# Bettergrow Resource Recovery Facility Wetherill Park Modification 3

State Significant Development Modification Assessment  
(SSD-7401-Mod-3)

March 2022

Figure 4 | Proposed Site Plan at Ground Level (DA004 Issue D) SSD-7401-Mod-3

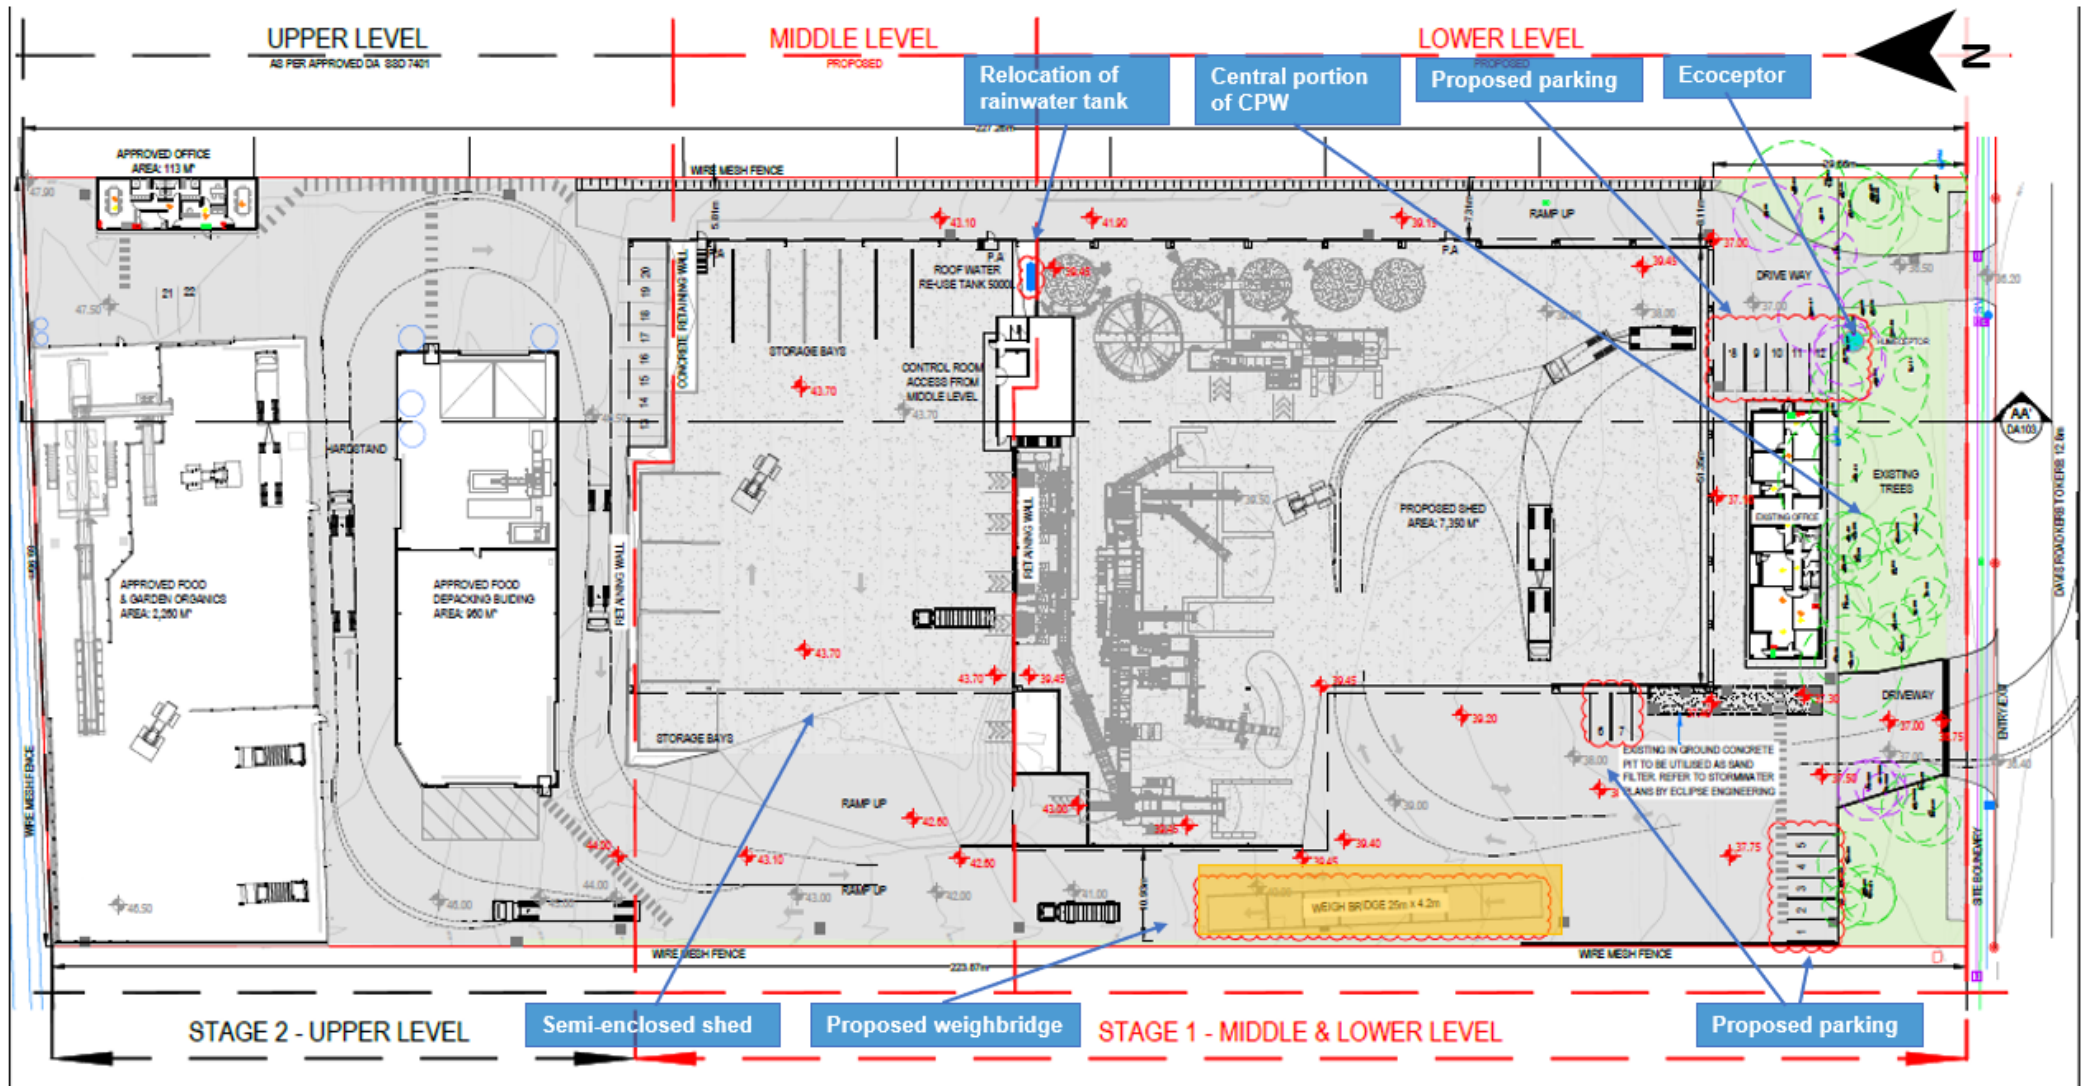
The approved stormwater treatment device, which removes total suspended solids (TSS) and entrained hydrocarbons, would be relocated to the north-west corner of the central portion of vegetation on site (see **Figure 4**). The type of treatment device would also be changed from a Humeceptor to a SPEL Ecoceptor 6000 series, which has the same dimensions as the Humeceptor. Also, the 5 kilolitre (kL) underground rainwater tank would be changed to an above-ground tank and relocated to inside the drill muds processing shed.

The proposed changes to the weighbridge and carparking arrangements involve replacement of the five approved weighbridges located within the semi-enclosed shed (**Figure 3**) with one 4.2 metre (m) long weighbridge located externally, approximately 55 m from the site entrance on Davis Road (**Figure 4**). To facilitate the new external weighbridge, changes are proposed to the 12 carparking spaces in the south west corner of the site, with the total number of car parking spaces remaining unchanged. Five spaces would be relocated to directly east of the office building, two would be located north of the inground concrete pit and another five would be located immediately north of the south west portion of vegetation.
